Seismic Walkdown Checklist (SWC)

Equipment ID No. Q2P17HV3095 Equip. Class¹ 7

Equipment Description CCW SUPPLY TO EXCESS LETDOWN HEAT EXCHANGER

Equipment ID No. Q2P17HV3095 Equip. Class 7

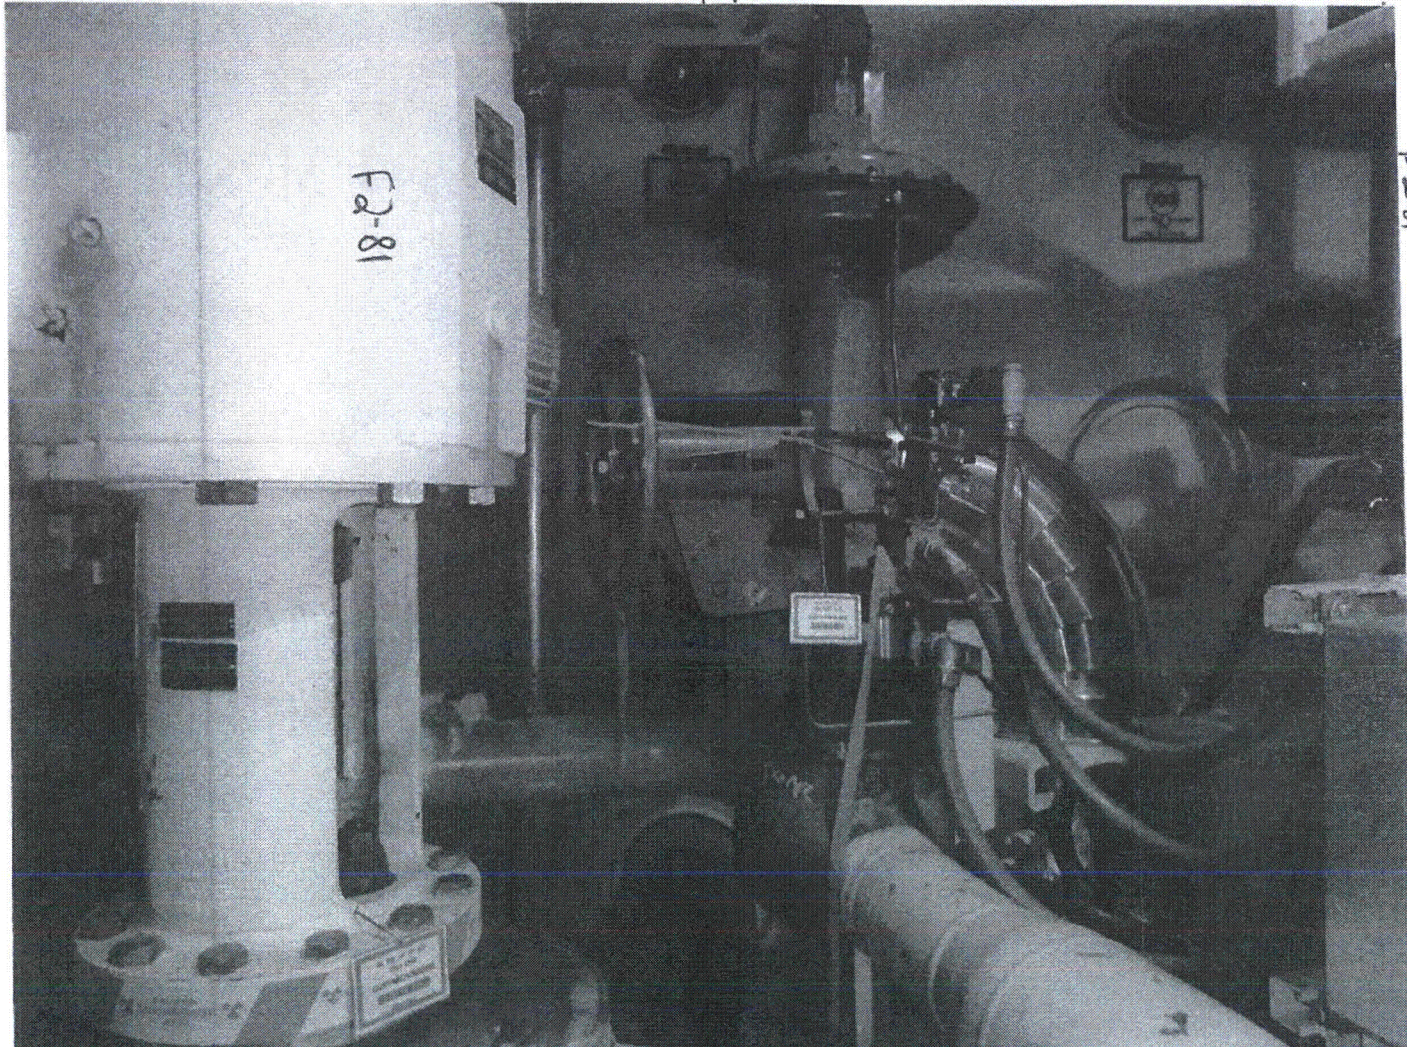
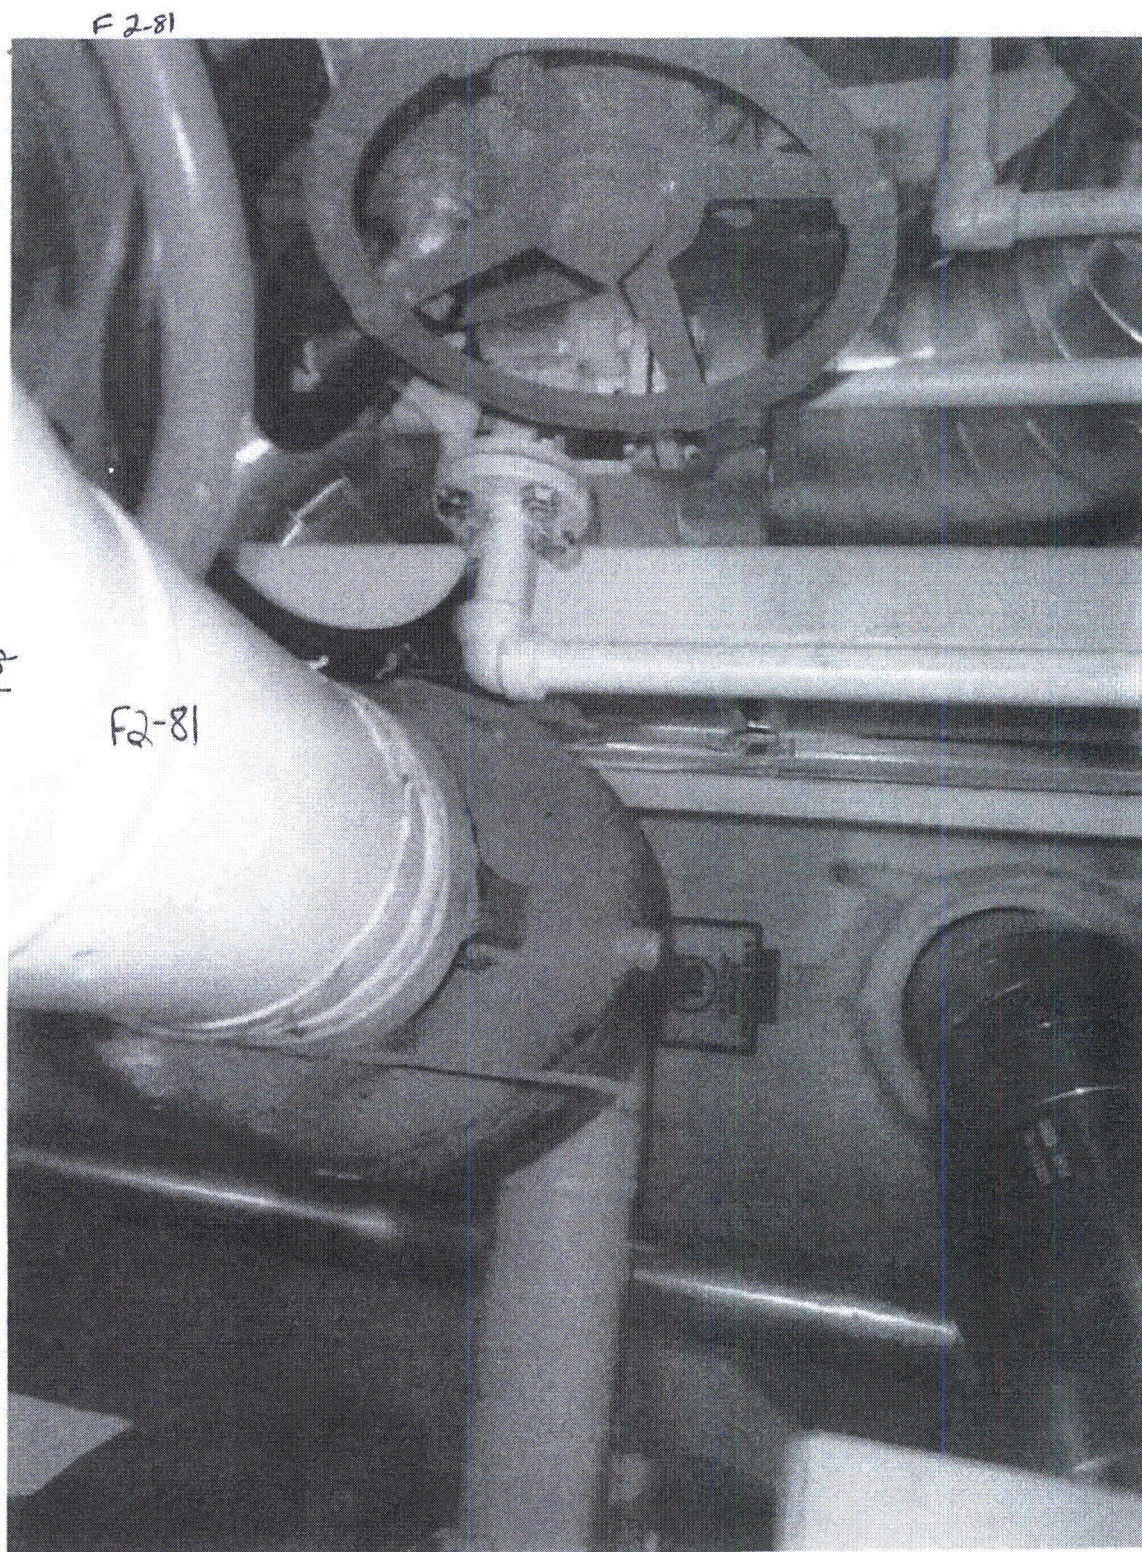
CLOSE (1" AWAY) TO 1 1/2" ANCHORED / SUPPORTED LINE.
MASS IS SO SMALL THAT IF ANY INTERACTION OCCURED THAT IT

Comments (Additional pages may be added as necessary) NONE
IS NO SEISMIC CONCERN TO VALVE, OKAY

Equipment ID No. Q2P18C002B Equip. Class: 12

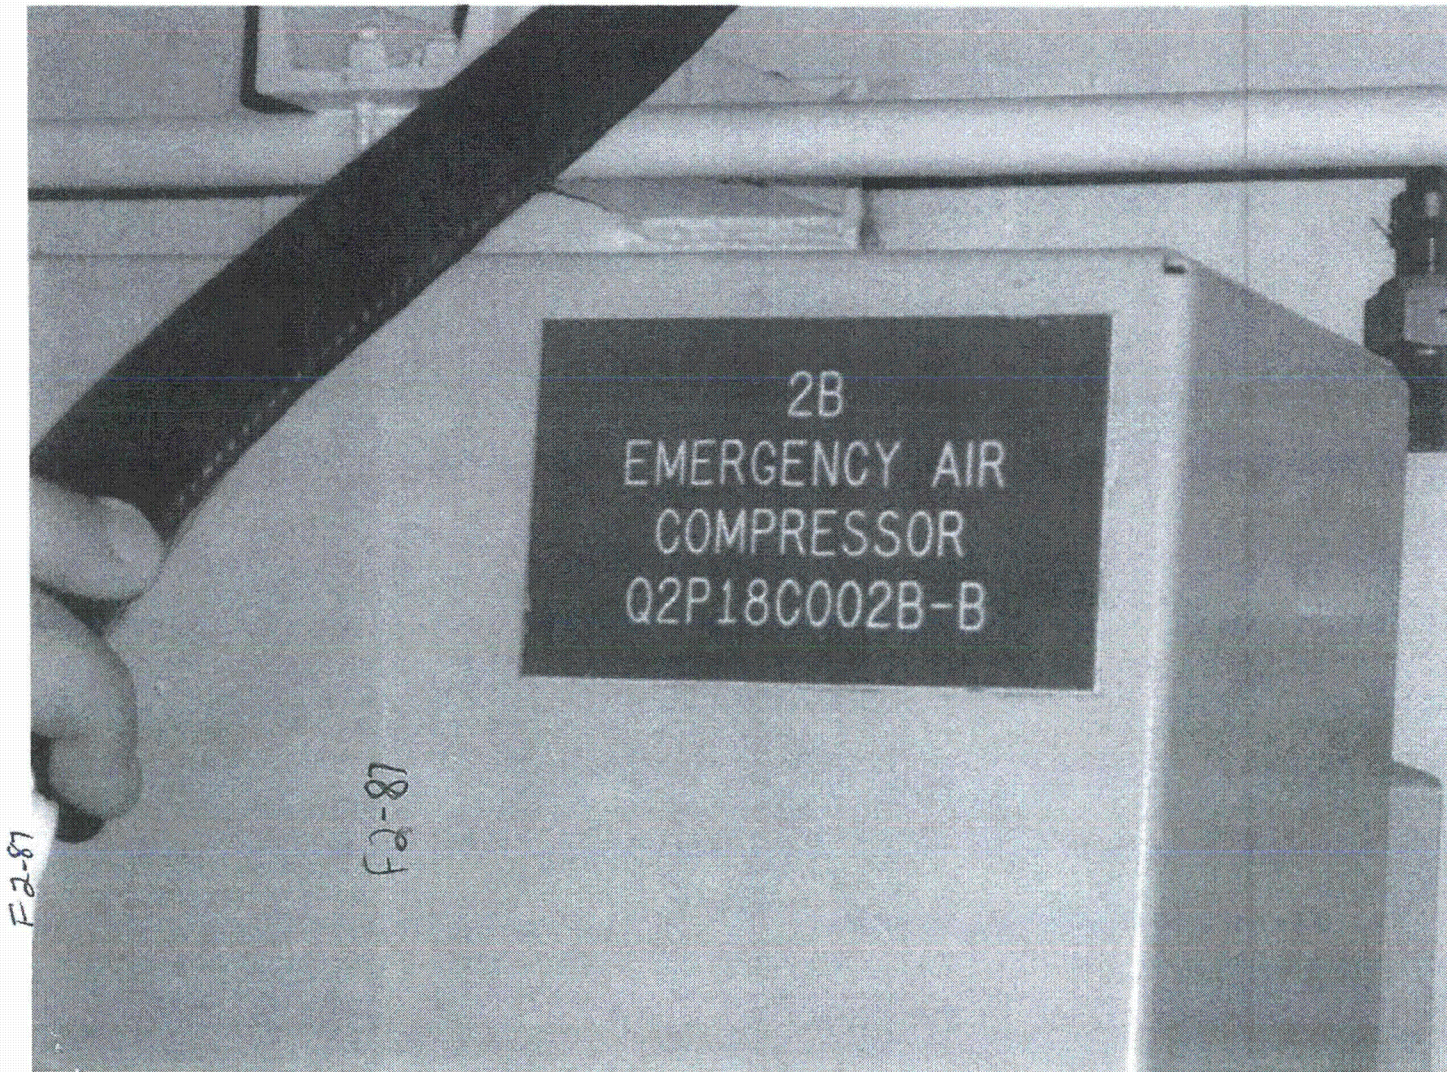
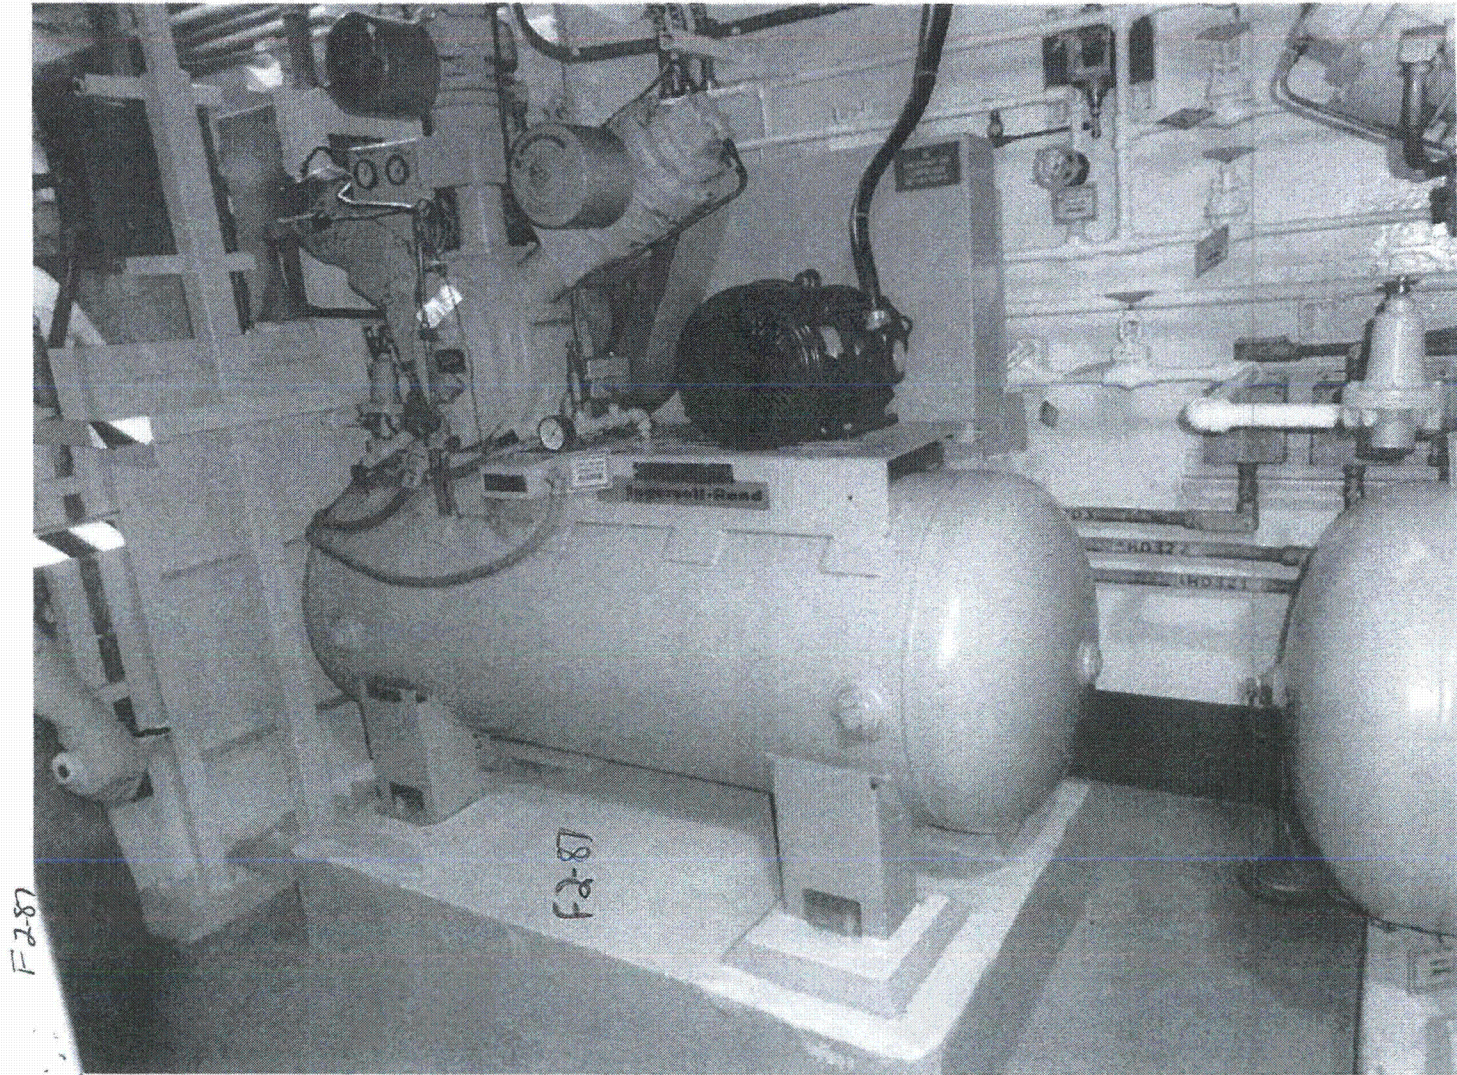
Valve N2P20V099 handle resting in contact w/ heat exchanger insulation. Heat exchanger is well support & lateral movement of pipe is not Credible. no operability issue.

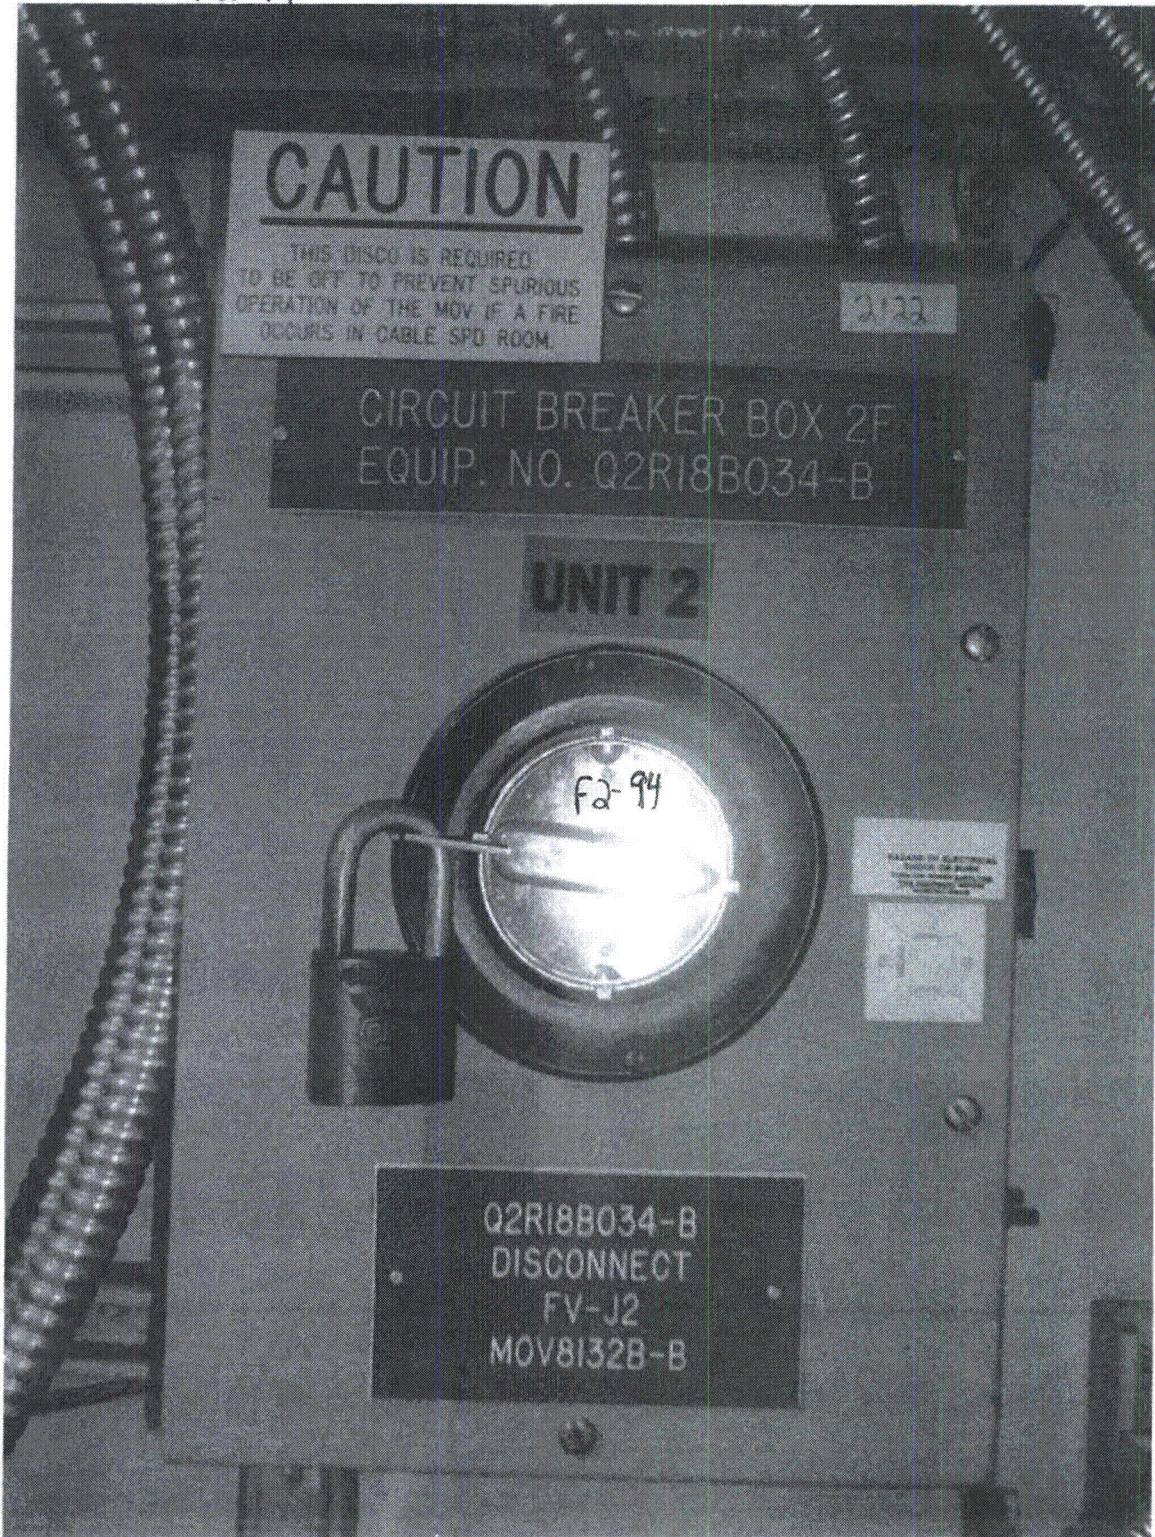
Observed top two connection clips compliant w/ photos shown SEWS for component Q2RBB034-B, bottom two connection clips are identical to top two. Also, we observed four unistrut bolts which is a typical unistrut connection. Additionally observed 12 unistrut

in three adjacent identical circuit breakers which are also identical. Anchorage configuration is validated.

Comments (Additional pages may be added as necessary) There are no plant drawings for the anchorage of this wall component. The SEWS SEWS Package evaluated the anchorage based on judgement. The anchorage is not specifically described. However, the anchorage is shown in a picture attached to the SEWS. The configuration of the anchorage in the field was determined to match the configuration from the picture as well as to match the anchorage configuration of other similar components in the area.
